Title		
<b>OMC BOARD - Production</b>		
Size	Number	Revision
C	<b>D1003116_v2</b>	<b>2</b>
Date:	23/11/2010	Sheet 1 of 2
File:	G:\Ron\...\OMC_Board_v2.SchDoc	Drawn By: Ron Cutler

Title			OMC DRIVER CHANNEL - Production		
Size	Number	Revision			
D	D1003116 v2	2			
Date	23/11/2010	Sheet 2 of 2			
File	G:\Rom\OMC_Driver_v2\SchDoc	Drawn By:	Ron Cutler

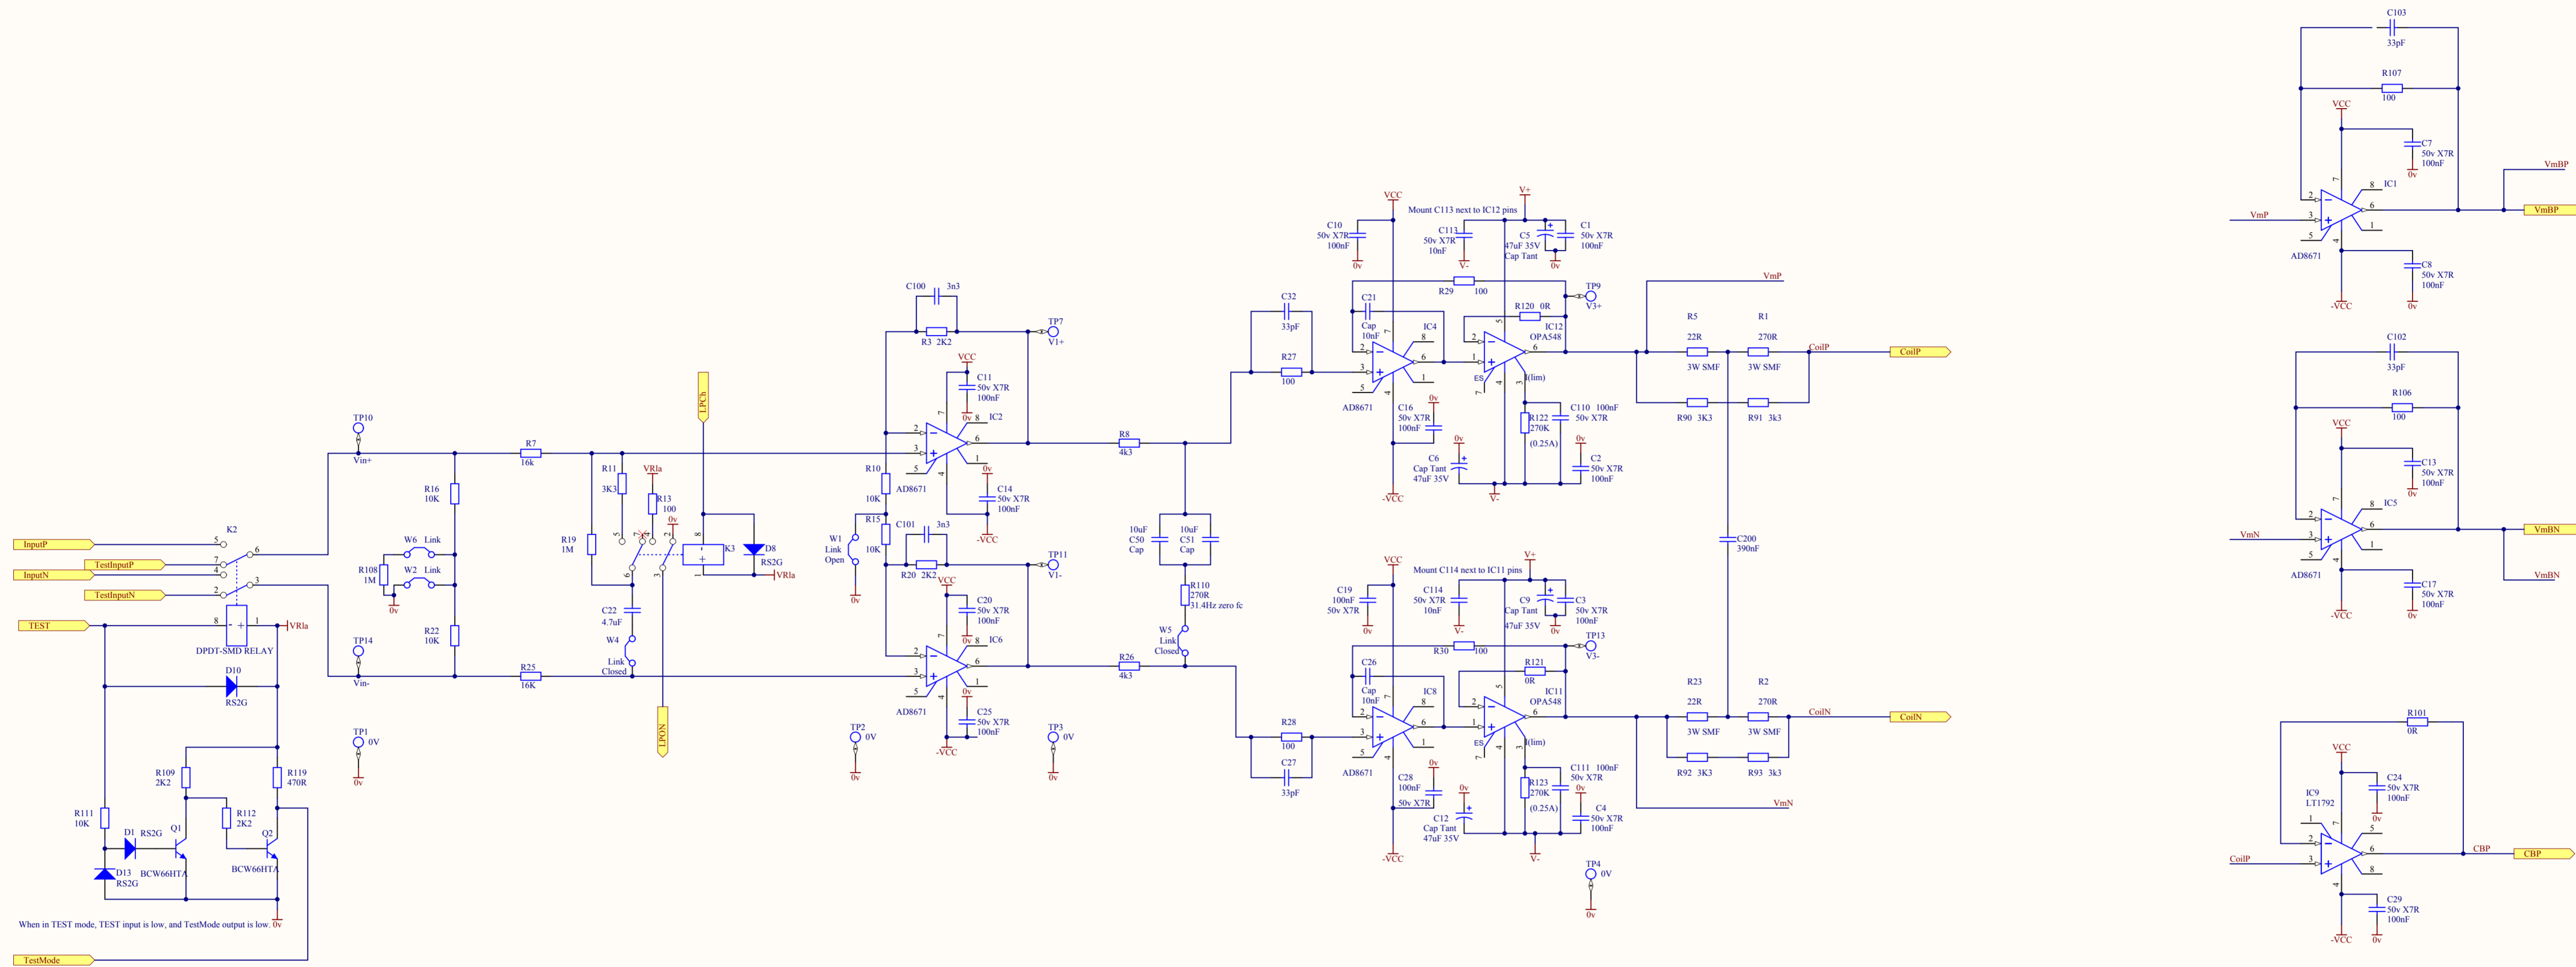
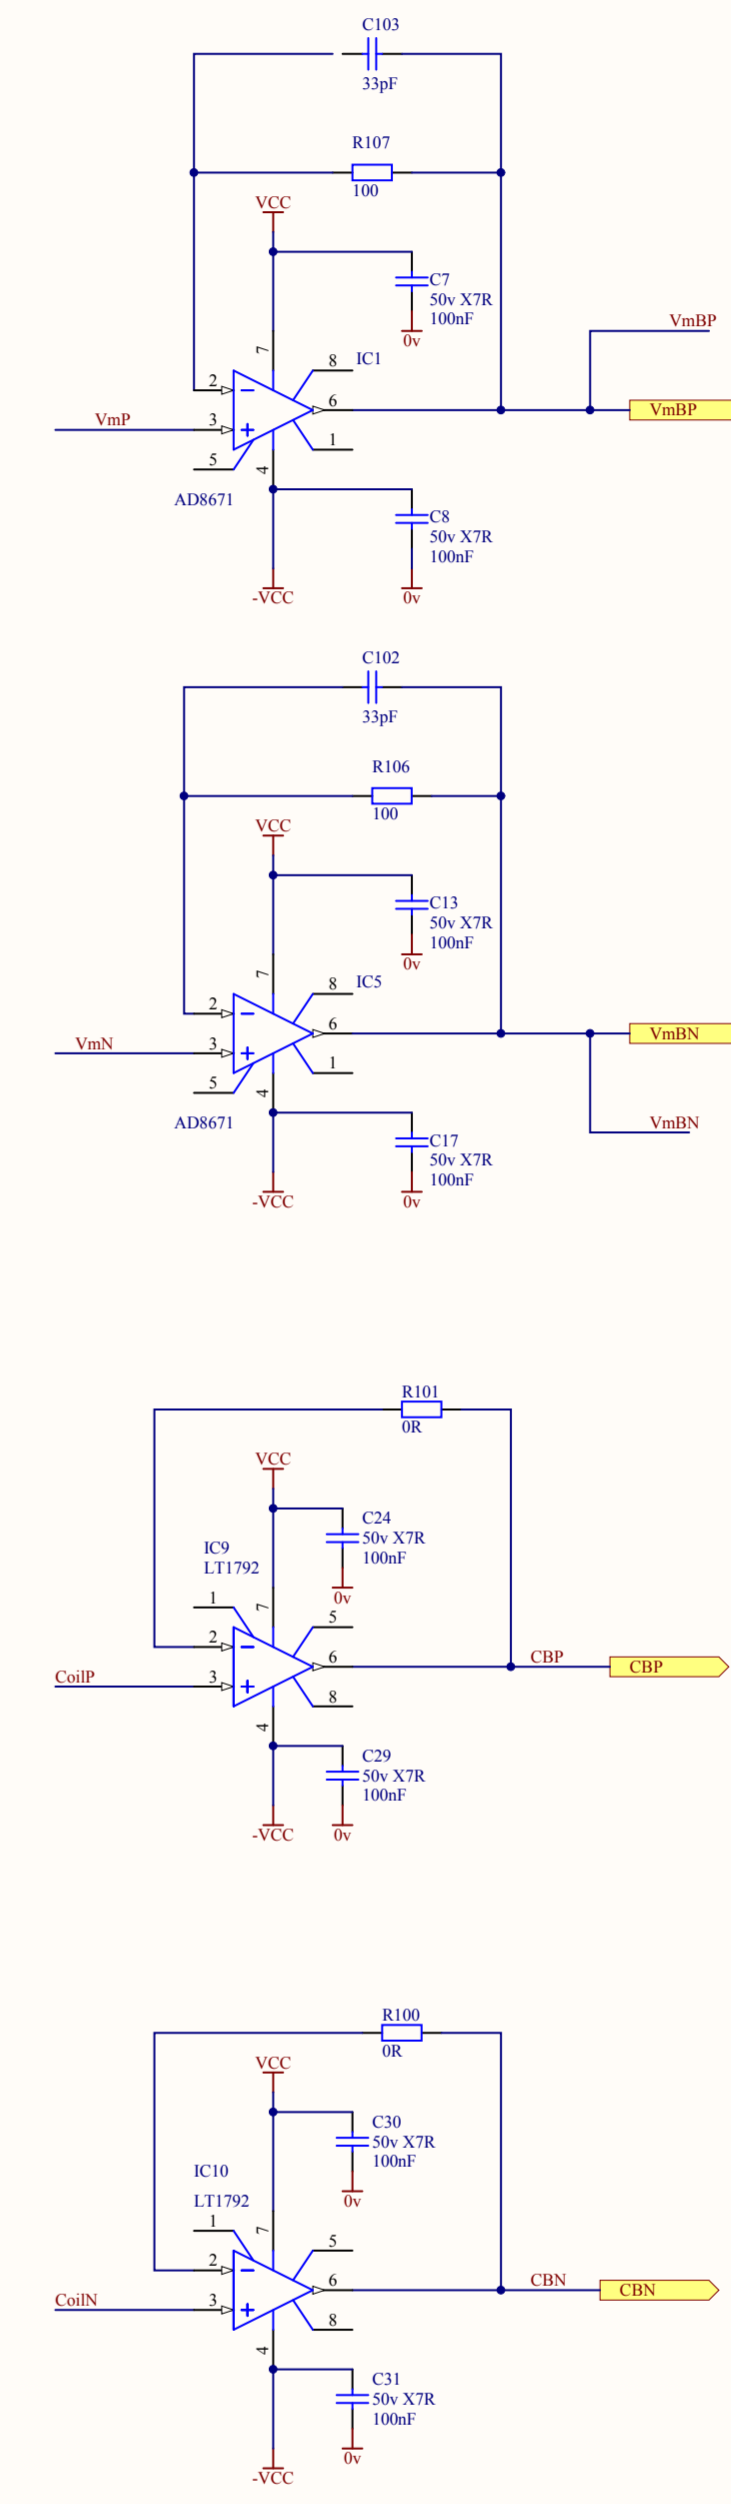
- CHANGES**
- (1) IC4 and IC8 changed to AD8671
  - (2) C21 and C26 changed to 10nF; V2
  - (3) C102, C103 added (33pF)
  - (4) IC1, IC5 changed to AD8671
  - (5) Silk Screen changed to OMC
  - (6) Resistor value changes: R1, R2 = 270R 3W. R5, R23=22R 3W. R90, R91,R92,R93 = 3K3
  - (7) Capacitor C200 added after assembly
